LOHAN & DONNELLY
Consulting Civil & Structural Engineers

Date: August 20th, 2020
Re: Response to Request for Further Information for House Development at
29, Willington Crescent, Dublin 6W
Our Ref: 1721

Project: 29 Willington Crescent

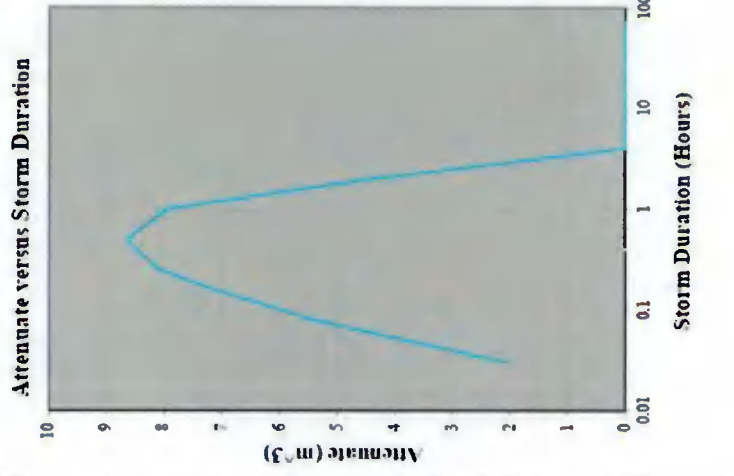
3. The applicant is requested to submit the following: (a) a report showing site specific soil percolation test results and design calculations for the proposed soakaway in accordance with BRE Digest 365 – Soakaway Design. (b) a drawing showing plan & cross-sectional views, dimensions, and location of proposed soakaway. Any proposed soakaway shall be located fully within the curtilage of the property and shall be:

- (i) At least 5m from any building, public sewer, road boundary or structure.*
- (ii) Generally, not within 3m of the boundary of the adjoining property.*
- (iii) Not in such a position that the ground below foundations is likely to be adversely affected.*
- (iv) 10m from any sewage treatment percolation area and from any watercourse / floodplain.*
- (v) Soakaways must include an overflow connection to a public surface water sewer.*

A soil infiltration test has been carried out and included in our response. The results found that the soil is not suitable for a soakaway. As an alternative it is proposed to install a permeable paving system. As there will be insufficient infiltration, the paving is to be designed as a tanked system with a 150Ø pipe. This will allow water which cannot be infiltrated into the soil to drain into the drainage network where flow will be limited to 2l/s using a hydrobrake installed in the last manhole on the site.

The paving will be tanked around both existing and proposed structure and out 1.5m from the houses. The remaining paved areas will be installed with a permeable membrane to allow some infiltration and therefore reduce run-off into the main sewer line. See attached calculations.

Roof Area: 206.1 m² Permeable: 196.5 m² Grass: 159.2 m² Equivalent Impermeable Area: 345.96 m² Attenuated Flow Rate: 2 l/s
I. Factor: 0.80 I. Factor: 0.80 I. Factor: 0.15

Storm Duration (Hours)	Rainfall (mm)	Total Surface Water (m ³)	Allowable Discharge (m ³)	Attenuate (m ³)
0.03	6.50	2.25	0.216	2.03
0.08	17.40	6.02	0.576	5.44
0.166	24.30	8.41	1.1952	7.21
0.25	28.60	9.89	1.8	8.09
0.50	35.40	12.25	3.6	8.65
1.00	43.80	15.15	7.2	7.95
2.00	54.30	18.79	14.4	4.39
4.00	67.20	23.25	28.8	0
6.00	76.20	26.36	43.2	0
12.00	94.30	32.62	86.4	0
24.00	116.80	40.41	172.8	0
48.00	130.10	45.01	345.6	0
72.00	141.30	48.88	518.4	0

Maximum Volume of Attenuate: 8.65 m³ Climate Change = 1.2 Required Attenuation Volume = 10,376 m³
